III. CORRECTIONS AND ADDITIONS TO THE DRAFT SEIR

The following corrections and additions are set forth to update the Cedars-Sinai Medical Center West Tower Project Draft Supplemental Environmental Impact Report (SEIR) in response to comments received through out the public review period, as well as other changes necessary to reflect accuracy of Project information. Changes to the Draft SEIR are listed by the corresponding Draft SEIR section/subsection and page number, as appropriate. An excerpt of the affected text has been included and corrections/additions to the Draft SEIR text are provided in underline or ~~strikeout~~ to indicate additions and deletions to the Draft SEIR, respectively.

FIGURE 46-A

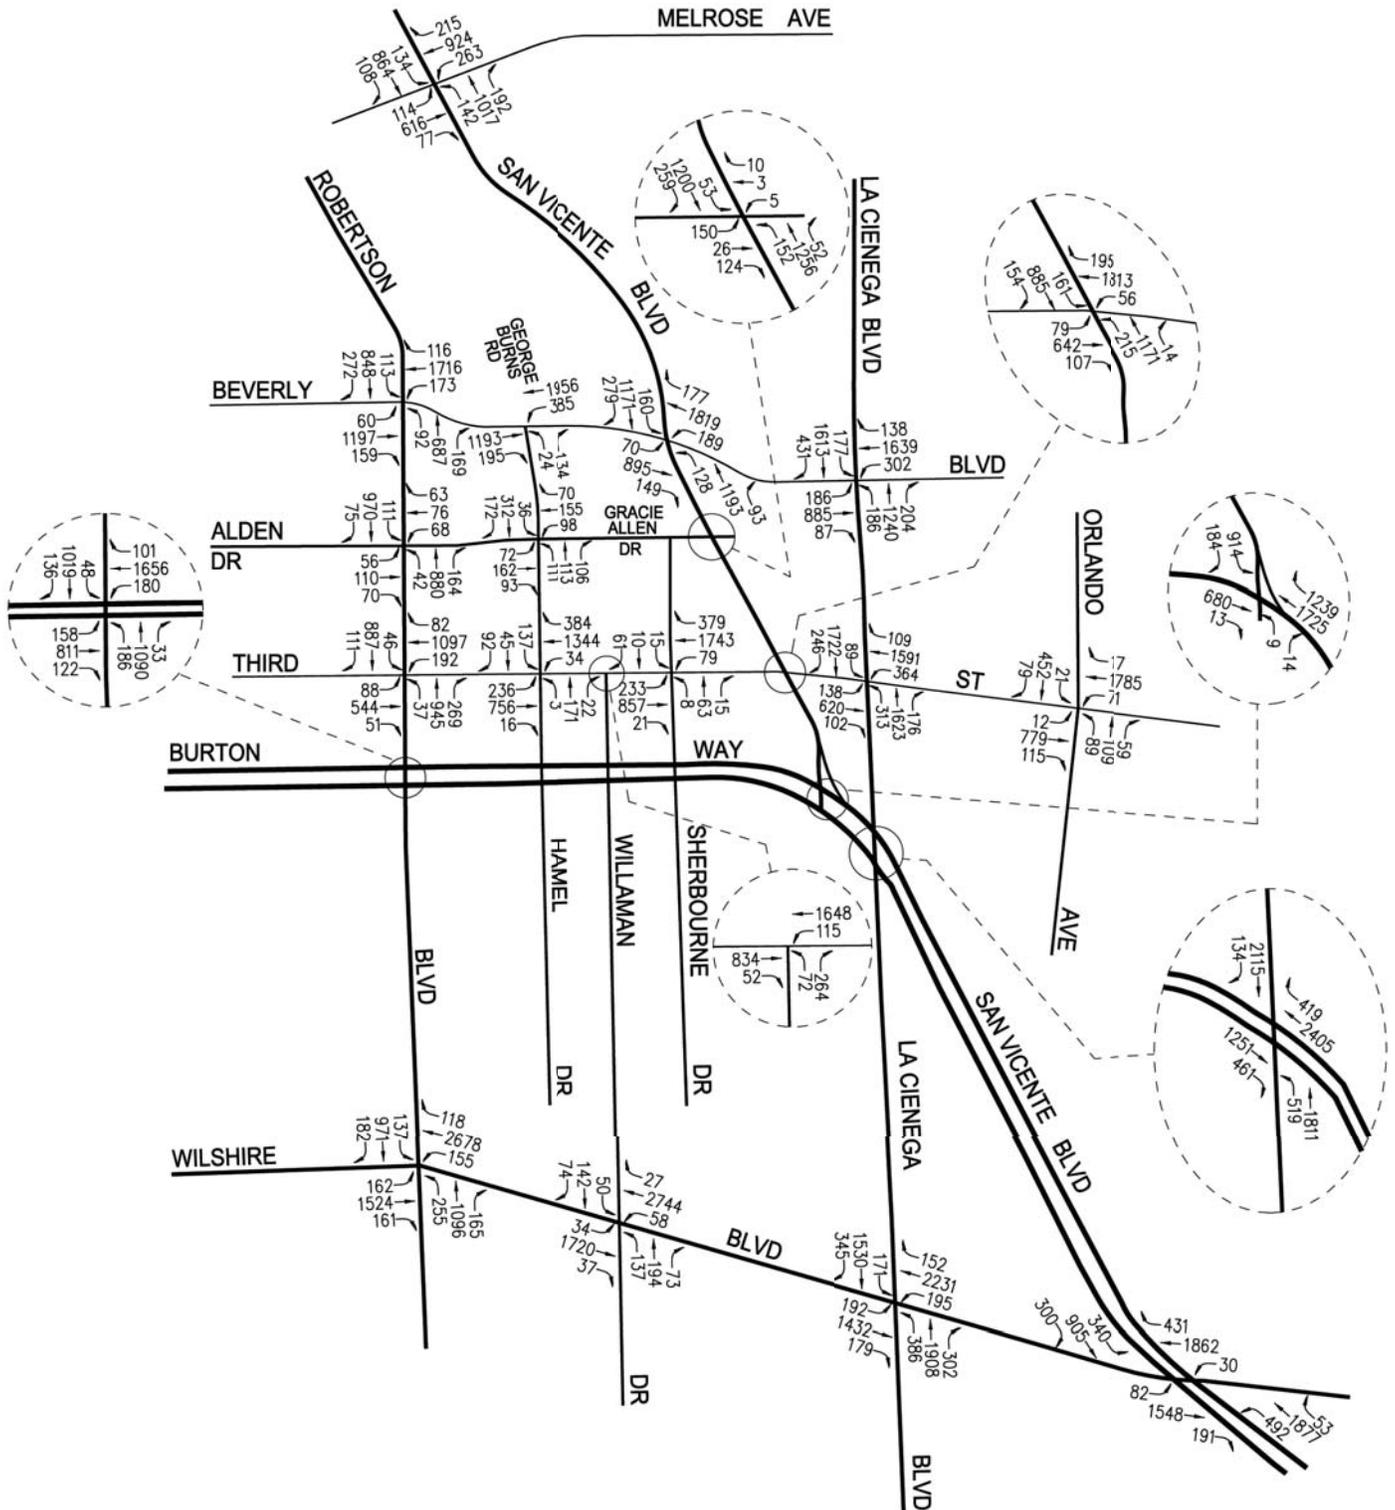
6. Page 214, Insert *Figure 46-A: Future with Project Traffic Volumes for A.M. Peak Hour* and *Figure 46-B: Future with Project Traffic Volumes for P.M. Peak Hour* after page 214 as pages 214-A and 214-B.

FIGURE 7-2
RELATED PROJECTS TRAFFIC VOLUMES
AM PEAK HOUR

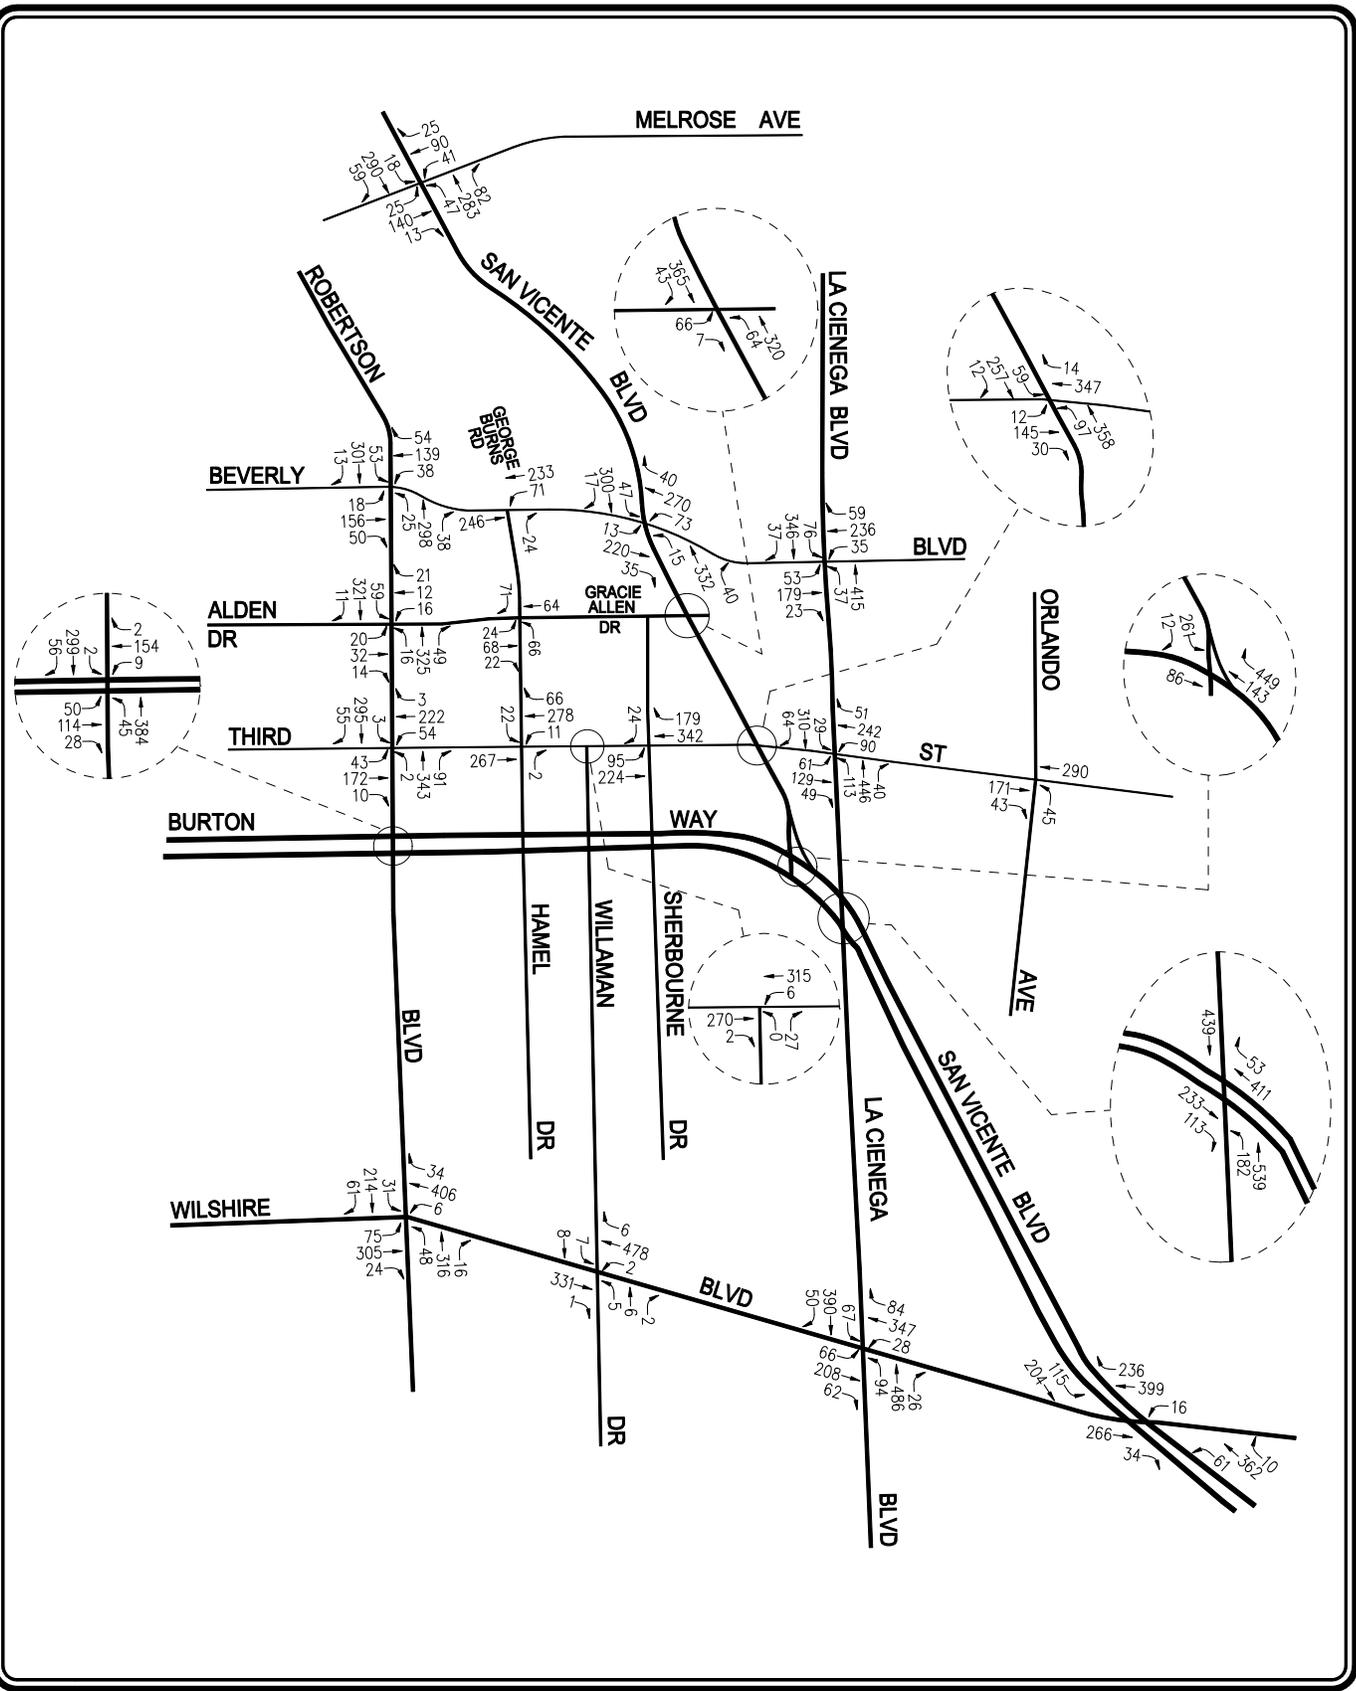
- Replace *Figure 7-2: Related Projects Traffic Volumes, AM Peak Hour* with attached Figure 7-2
- Replace *Figure 7-3: Related Projects Traffic Volumes, PM Peak Hour* with attached Figure 7-3

FIGURE 9-3 FUTURE PRE-PROJECT TRAFFIC VOLUMES AM PEAK HOUR

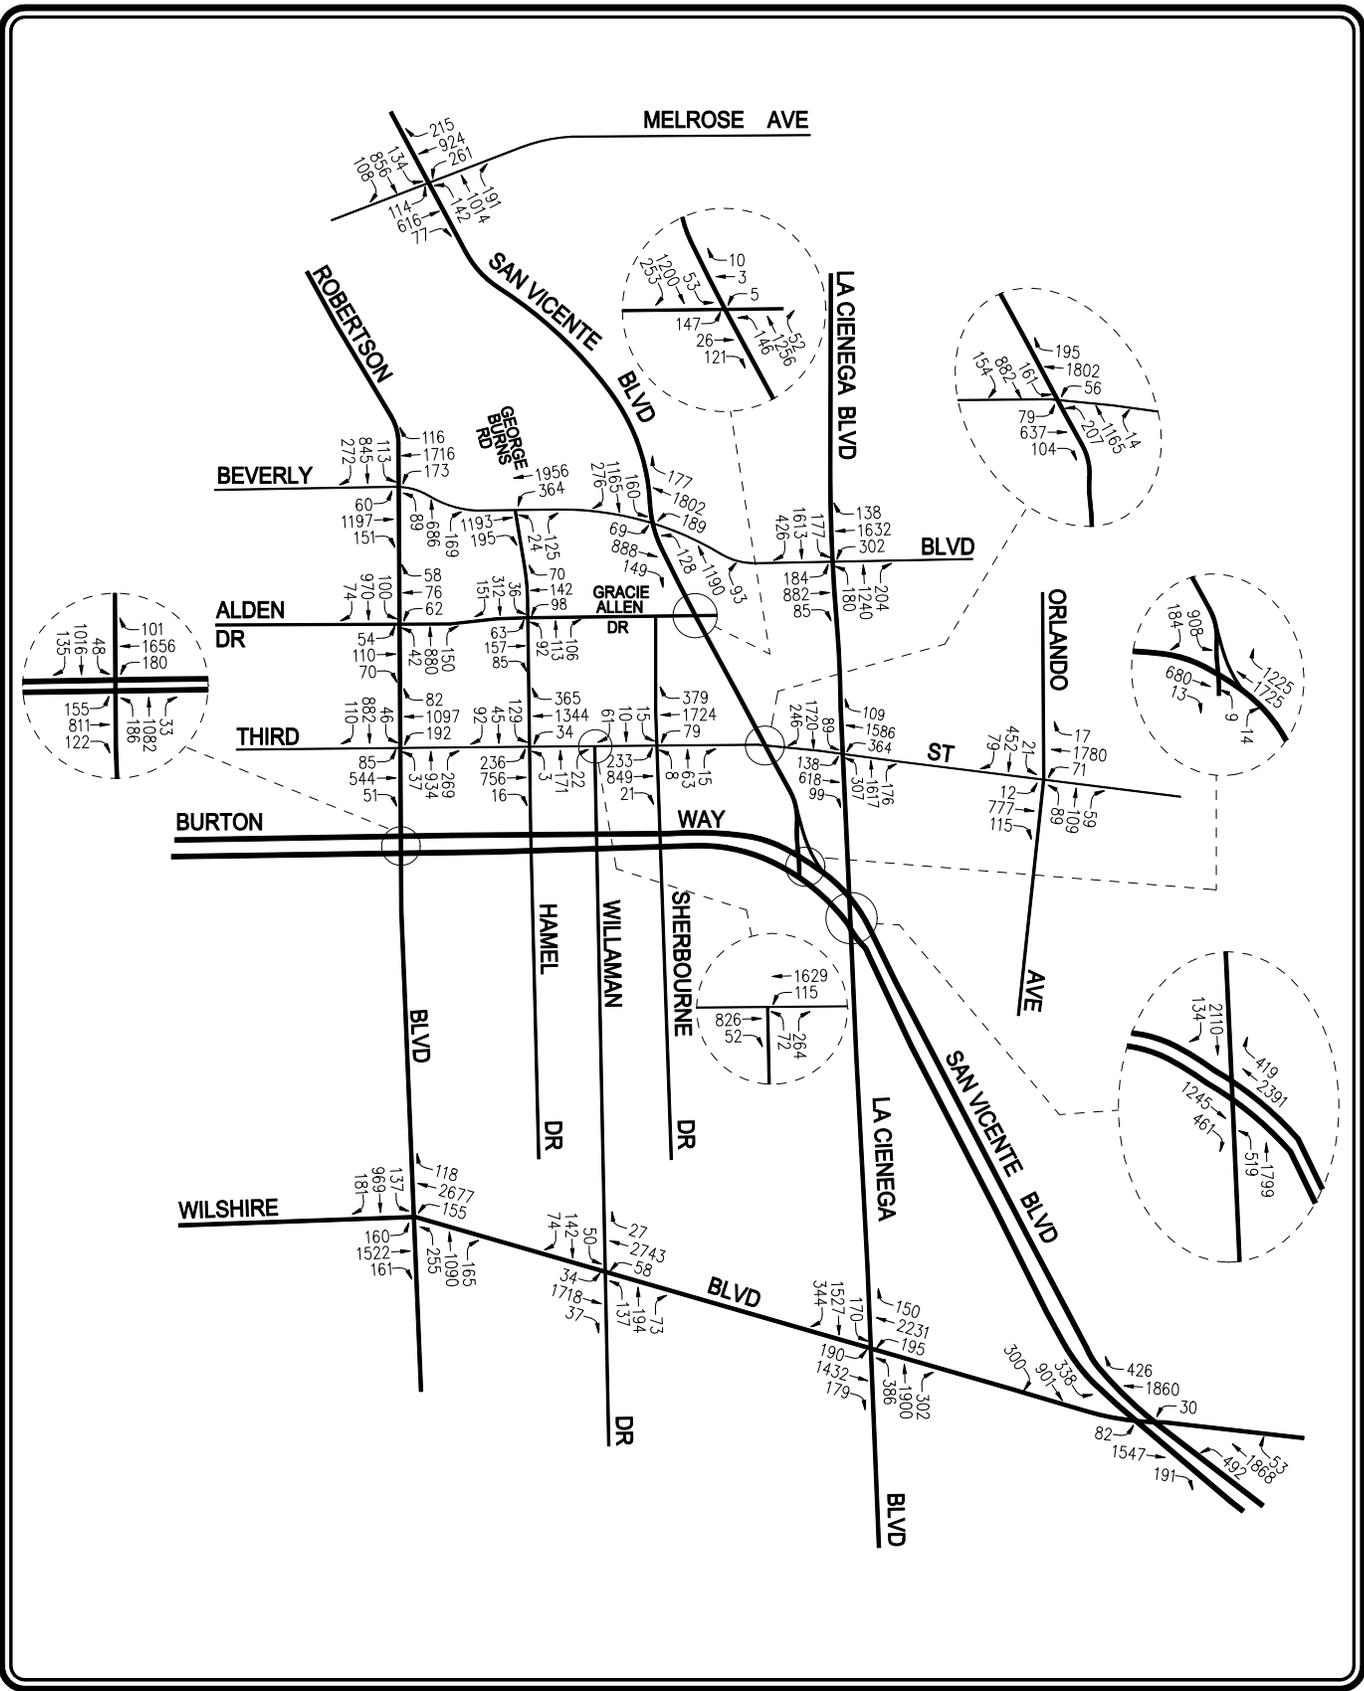
- Replace *Figure 9-3: Future Pre-Project Traffic Volumes, AM Peak Hour* with attached Figure 9-3
- Replace *Figure 9-4: Future Pre-Project Traffic Volumes, PM Peak Hour* with attached Figure 9-4
- Replace *Figure 9-5: Future With Project Traffic Volumes, AM Peak Hour* with attached Figure 9-5
- Replace *Figure 9-6: Future With Project Traffic Volumes, PM Peak Hour* with attached Figure 9-6
